**PARK CITY PLANNING DEPARTMENT  
STAFF REPORT**

TO: HISTORIC DISTRICT COMMISSION  
FROM: PLANNING STAFF  
DATE: MAY 20, 1996  
RE: 332 DALY AVENUE - CERTIFICATE FOR APPROPRIATENESS FOR  
DEMOLITION

**Author:** Anya Grahn, Historic Preservation Planner  
**Subject:** Material Deconstruction and Reconstruction Review  
**Address:** 243 Daly Avenue  
**Project Number:** PL-16-03172  
**Date:** May 3, 2017  
**Type of Item:** Administrative – Material Deconstruction and Reconstruction

**Progression of Development:**

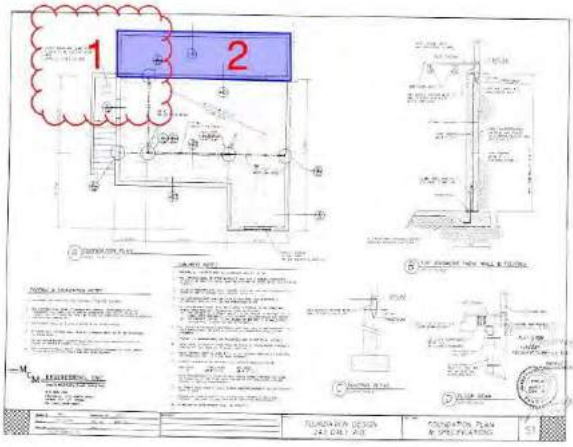
1. The lime green shaded areas show the original hall-parlor house constructed before 1889. These areas are historic.
2. The darker green shaded areas are the addition that created the cross-wing between 1927 and 1941. These areas are historic.
3. The orange shaded area is the shed addition to the northeast corner. The construction materials of this section are contemporary; however, the overall form and location of the shed addition is consistent with that seen in the historic photograph.
4. The red shaded areas show the improvements made after 1941: building a new sloped roof form over the original roof form of the façade, constructing an exterior staircase and extending the porch to the north side of the projecting ell, rear additions, new concrete basement foundation, etc.

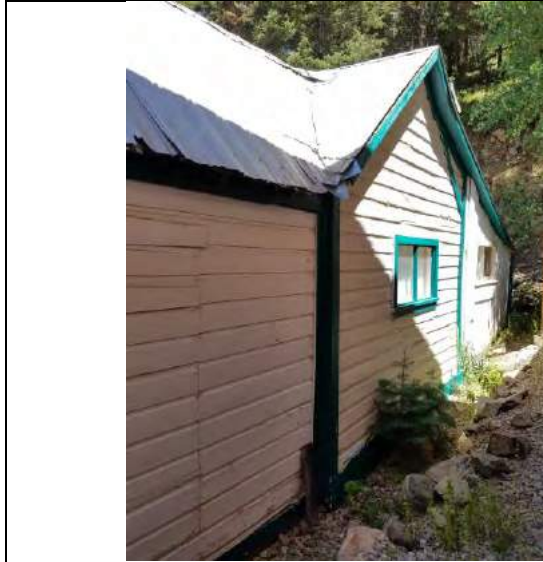
*This photograph of the south (side) elevation shows the transition from historic drop-novelty wood siding to plywood. The gable is original to the cross-wing house and the projecting ell is nearest to photographer. Note the plywood material on the shed addition to the rear.*

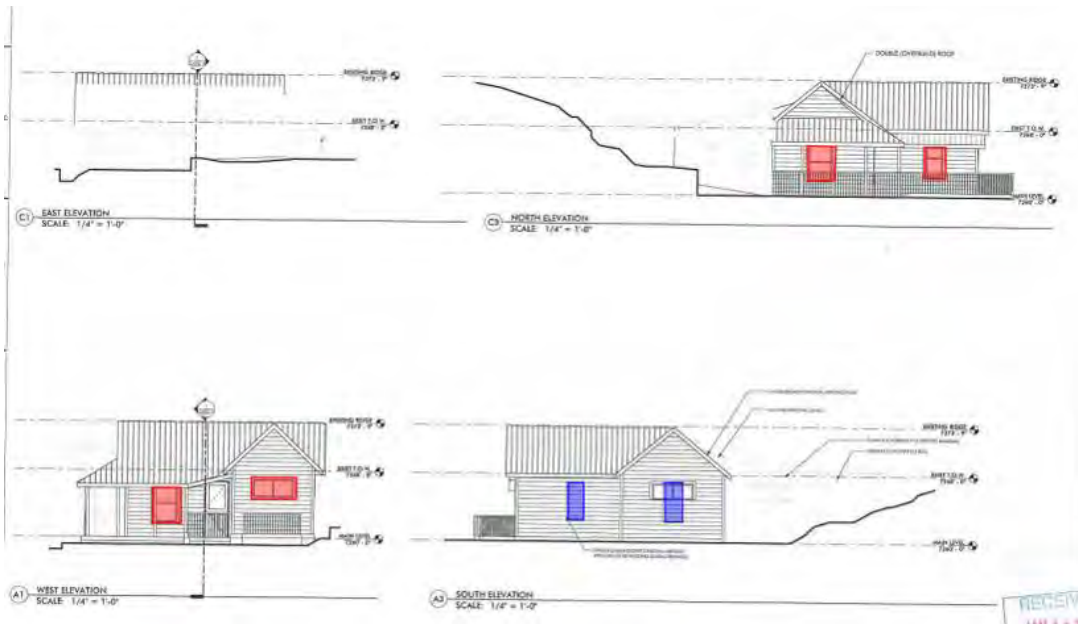
The applicant is proposing to remove the historic door on the front façade. The door is not a standard height and the frame has warped. The applicant has requested that they be able to expand the door opening to install a new IBC-compliant door. The original door opening is shaded in red below:

In the past, the HPB has been consistent about enforcing Specific Design Guideline B.4.1 which requires that historic door openings, doors, and door surrounds are maintained. Staff has added Condition of Approval #5 to address this issue:

*#5. The applicant shall maintain the dimensions of the extant historic door openings. The new door shall be consistent with historic door styles.*
